**SUBJECT: PALISADES NUCLEAR PLANT – STAFF ASSESSMENT OF RESPONSE TO
10 CFR 50.54(f) INFORMATION REQUEST – FLOOD-CAUSING MECHANISM
REEVALUATION (CAC NO. MF6128; EPID L-2015-JLD-0003)**

STAFF ASSESSMENT BY THE OFFICE OF NUCLEAR REACTOR REGULATION

PALISADES NUCLEAR PLANT

Figure 3.2-1. Map showing the key structures and identification numbers for the critical locations at safety-related structures of Palisades Nuclear Plant (Adapted from FHRR Figure 3.2-1). Locations are identified by numbers consistent with Table 3.2-1.

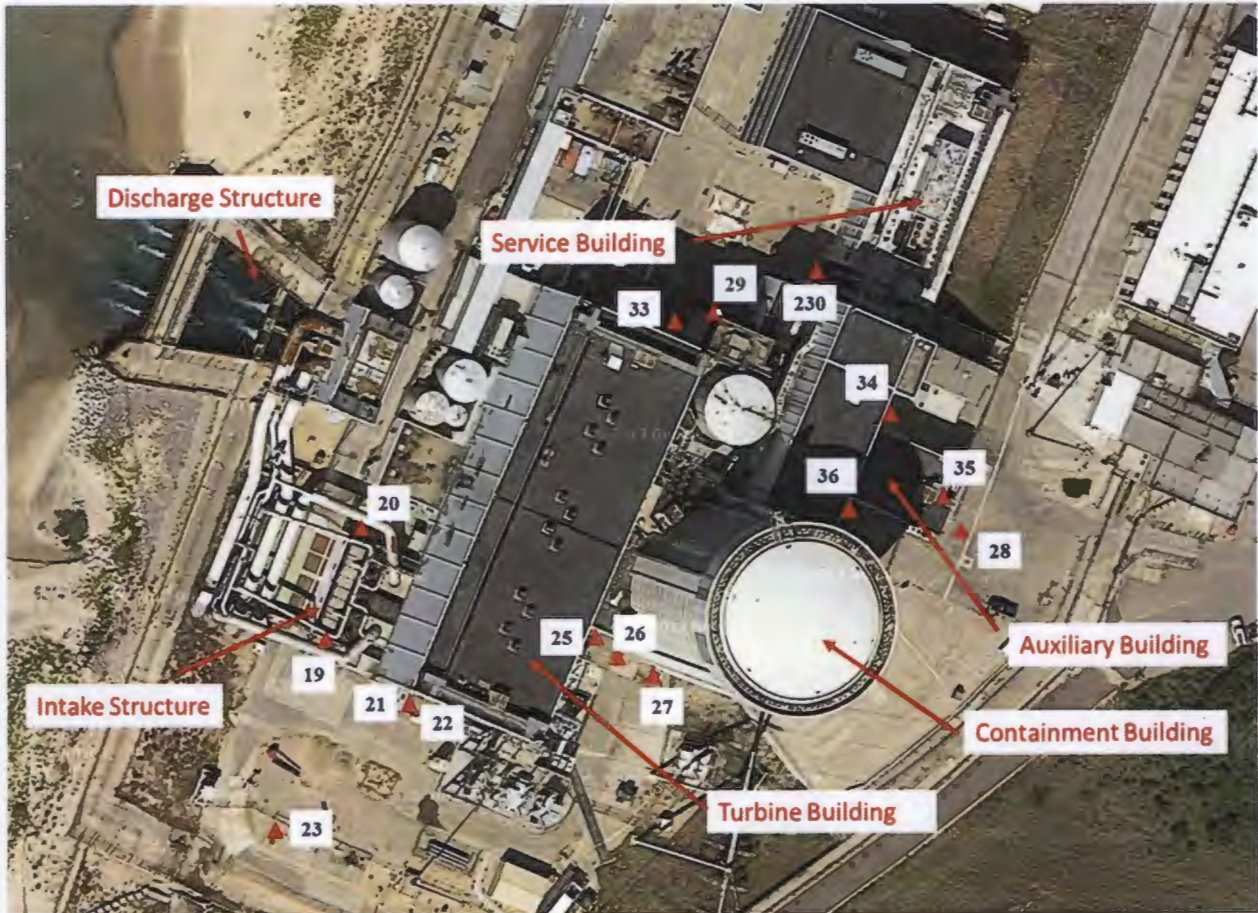
The licensee reported in its FHRR (Entergy, 2015) that the reevaluated flood hazard for LIP and associated site drainage is based on the stillwater water surface elevation (WSE) at the safety-related structures. The WSE ranges from 592.5 ft. NGVD29 near the North Entrance to the Screen House/Intake Structure to 626.1 ft. NGVD29 at the Administration Building Hallway East Entrance of the plant. The maximum flood depths of 9.8 ft. or WSE of 605.8 ft. NGVD29 were calculated to occur on the east side of the Service Building. The maximum flood depth ranged from 1.0 to 5.3 ft., or a WSE range from 592.5 to 626.1 ft. NGVD29, in the rest of the powerblock with varying ground surface elevations. Locations of the safety-related structures are presented in Figure 3.2-1.

The model results for the LIP analysis indicate that the maximum WSEs at the Palisades site range from 592.5 ft. NGVD29 near the North Entrance to the Screen House/Intake Structure (See Figure 3.2-1; location 20) to 626.1 ft. NGVD29 at the Administration Building Hallway East Entrance (see Figure 3.2-1; location 35). The licensee evaluated 15 critical locations as shown in Figure 3.2-1 and found that most of them have maximum WSEs below the protection elevation of 594.4 ft. NGVD29, except for four that are located at ground surface above 594.4 ft. NGVD29. The maximum water depths at these four locations ranges from 1.0 ft. to 2.2 ft.

The simulated maximum flood depths are 9.8 ft. on the east side of the Service Building and 1.0 ft. to 5.3 ft. in the rest of the powerblock. The CDB for LIP event includes maximum flood depths of 5 ft. on the east side of the Service Building and less than 0.5 ft. in the rest of the powerblock. On the basis of maximum flood depths computed from the FLO-2D model, the reevaluated LIP flood hazard is not bounded by the CDB.

The NRC staff confirms the licensee's conclusion that the reevaluated flood hazard for LIP and associated site drainage is not bounded by the CDB flood hazard. Therefore, the NRC staff expects that the licensee will submit a focused evaluation for LIP and associated site drainage for the Palisades site.
